Pressure Switches

The purpose of this supplement is to provide updated information for the standard pressure switches provided on Ingersoll-Rand compressor packages.

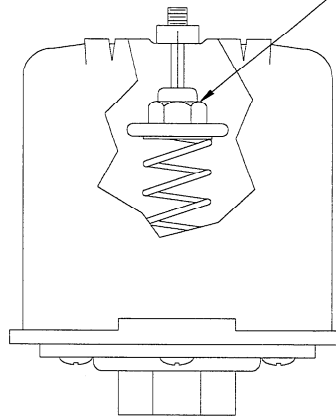
Standard pressure switches provided on Ingersoll-Rand compressor packages are no longer equipped with a differential adjustment control to establish the span between cut-in and cut-out pressure levels. The span is factory set for 40 ± 4 PSIG and cannot be adjusted.

Some pressure switches are equipped with an on-off lever used to open and close the electrical contacts inside the switch. THIS LEVER IS NOT A DIFFERENTIAL ADJUSTMENT CONTROL. The pressure switches with the on-off lever do not have a differential adjustment control.

The range adjustment control is still provided to set the cut-in and cut-out pressure levels.

The pressure switch is equipped with a range adjustment control only. No differential adjustment controls are provided.
